Access Compliance Report

Public Rights-of-Way

Intersection ID: 48453	Main Street: ALVARADO_WY	Cross Street: RED_RUST_LN	Location: NW
ADA ID: BC421B79A284	Ramp Type: Perp	Initial Pass/Fail: Fail	Overall Compliance: No
			Severity Score: 21.25

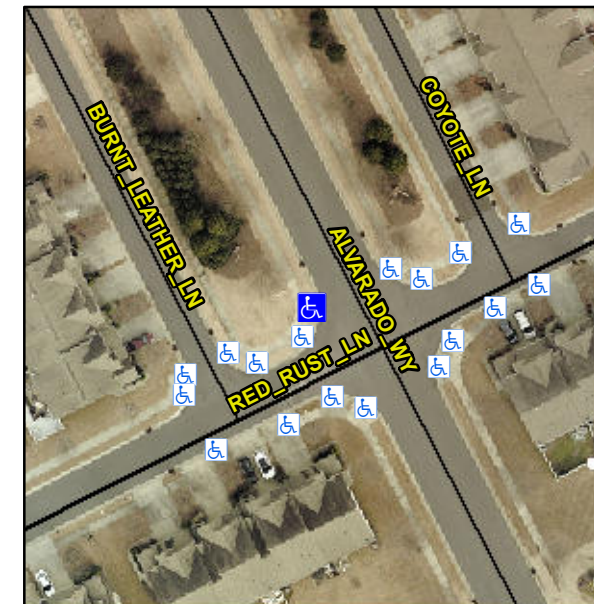
R304.5.1, R304.5.3

Compliance	Description	Data	Compliance	Description	Data
N/A	Ramp Length (in)	133.0	Yes	Ramp Slope (%)	5.2
No	Ramp Width (in)	46.5	No	Ramp XSlope (%)	5.7
N/A	Flare Type LT	N/A	N/A	Flare Type RT	N/A
N/A	Flare Slope LT (%)	N/A	N/A	Flare Slope RT (%)	N/A
N/A	Flare Traversable LT?	N/A	N/A	Flare Traversable RT?	N/A
N/A	Landing Length (in)	N/A	N/A	DWS Provided?	N/A
N/A	Landing Width (in)	N/A	N/A	DWS Contrast?	N/A
N/A	Landing Slope (%)	N/A	N/A	DWS Length (in)	N/A
N/A	Landing X Slope (%)	N/A	N/A	DWS Full Width?	N/A
N/A	Landing Curb? (Y/N)	N/A	N/A	DWS Offset (in)	N/A
N/A	Shared Landing?	N/A			
N/A	Gutter Ponding?	N/A	N/A	Gutter Slope (%)	N/A
N/A	Gutter Lip Ht (in)	N/A	N/A	Gutter X Slope (%)	N/A
N/A	Painted X Walk1?	No	N/A	Painted X Walk2?	N/A
	X Walk 1 Direction	To NE		X Walk 2 Direction	N/A
N/A	X Walk 1 Width (in)	N/A	N/A	X Walk 2 Width (in)	N/A
	X Walk 1 Slope (%)	2.7		X Walk 2 Slope (%)	N/A
	X Walk 1 X Slope (%)	3.6		X Walk 2 X Slope (%)	N/A

Remove & Replace Entire Ramp.
